Ref	Description of change
1.	<p>– Directly relating to shift in building position.</p> <p>a. Reduction of roof canopy length. The reduced length of canopy will absorb the entire shift of the building and the main intention of keeping the new building connected to the existing building will remain unchanged. Within this same area, the external stair location has been adjusted slightly to further underneath the roof canopy, providing better weather protection and easier movement around campus.</p> <p>b. Adjusted heights of windows. On the rear elevation, due to the location of the existing Ryecroft building, the sill levels of the windows can be updated to match the adjacent windows on this elevation. However, one window will need to retain a higher level sill due to the Ryecroft connection below.</p> <p>c. Revised landscape works. Due to the reduced demolition, no external landscape works will be required to the areas containing the existing gas and plumbing buildings. Furthermore, as the building has shifted away from this area, a revised service yard and vehicle access route has been provided. This will also require less landscape works and disruption than the previously submitted

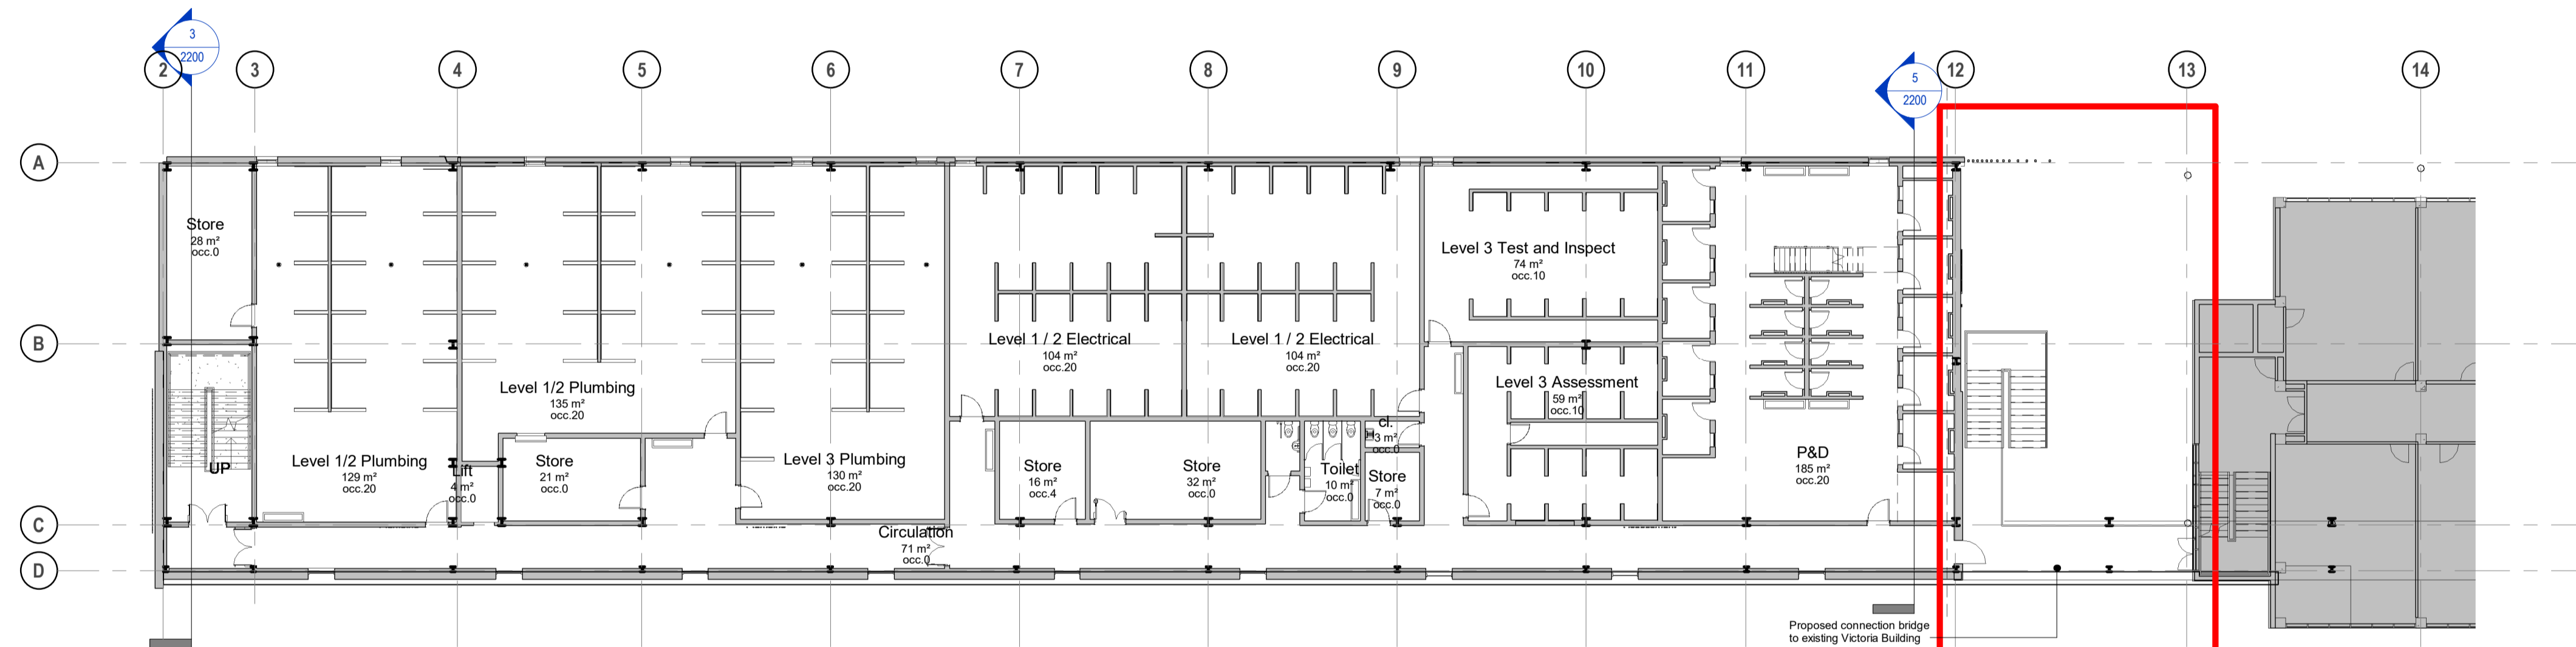
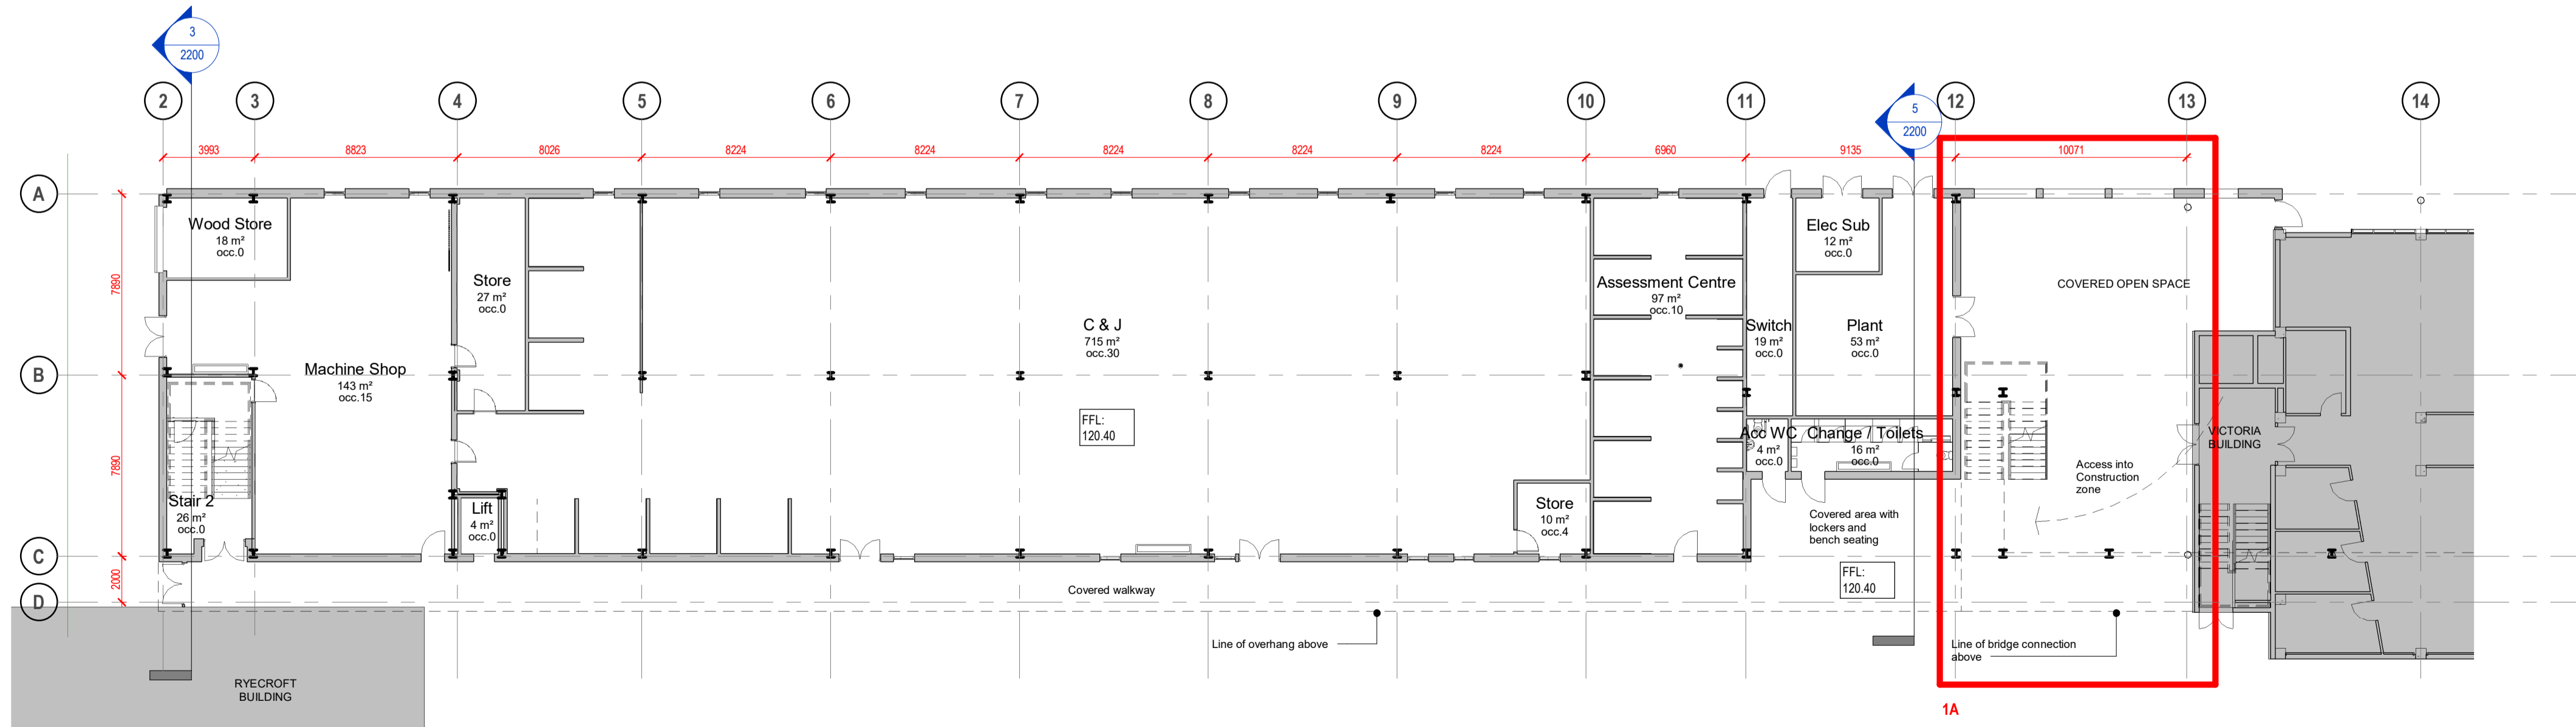
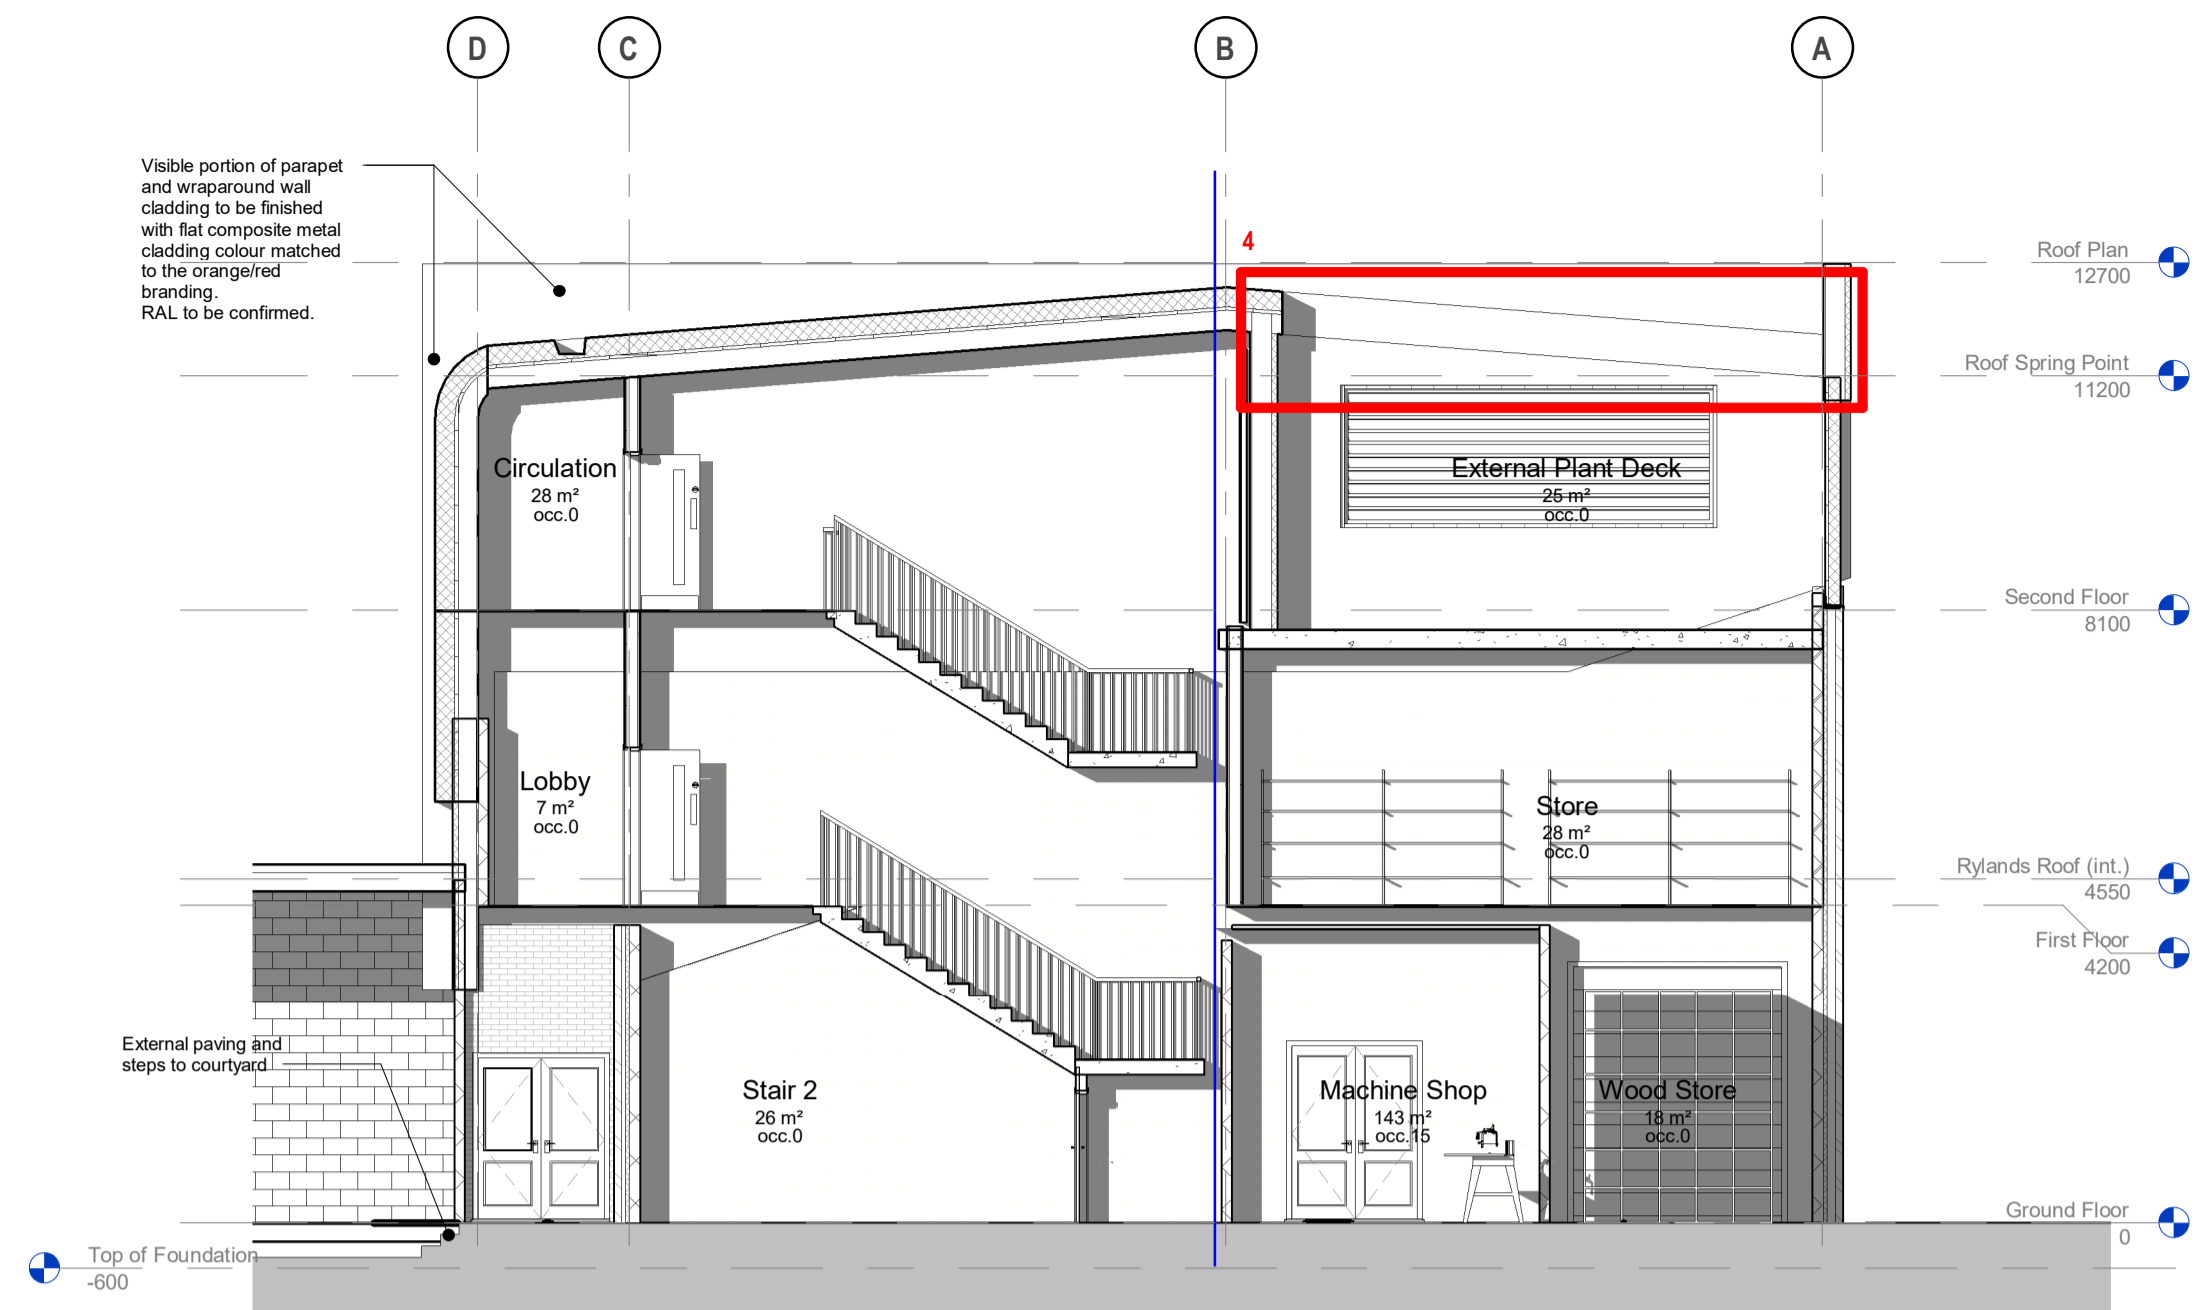
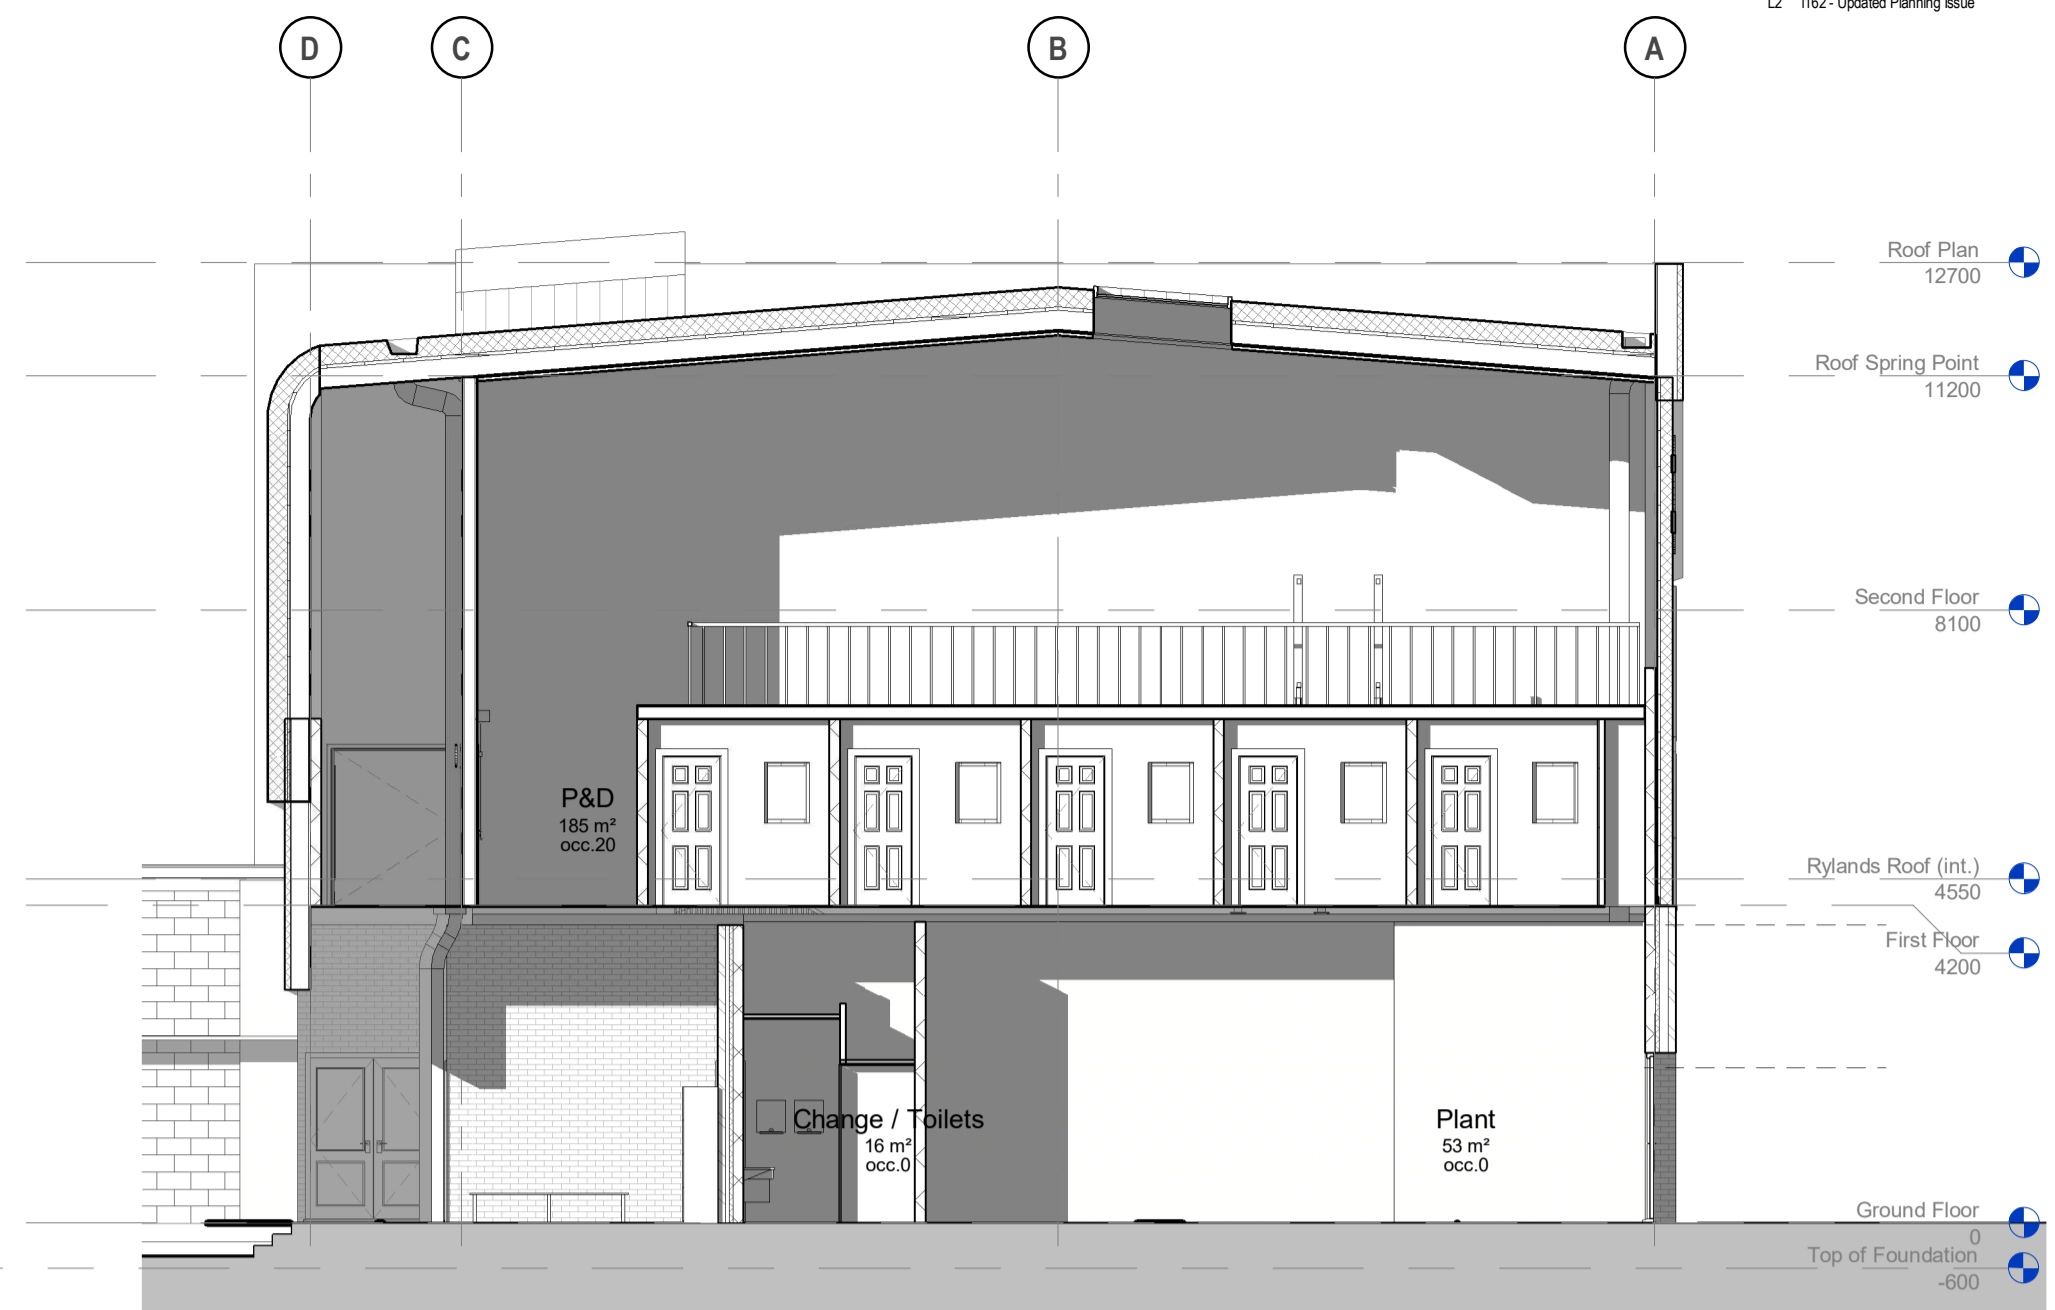
2.	<p>Reduced scope of demolition. Due to college requirements and as a result of the building shift, the following buildings will no longer need to be demolished:</p> <ul style="list-style-type: none"> Gas & Plumbing Joinery Brickwork

3.	<p>Lift overrun. The lift design will now require an overhead clearance that will result in a penetration to the roof. This is located on the internal courtyard side and should not be visible from any public areas. To further minimise visual impact within the campus, the lift overrun will be clad in a standing seam metal system to match the roof. Roof above External Plant Deck omitted. A small portion of the main roof above the External Plant Deck is to be omitted. This would not be visible from anywhere in public or on campus and will remain concealed behind the parapet that will wrap around this corner of the building.</p>
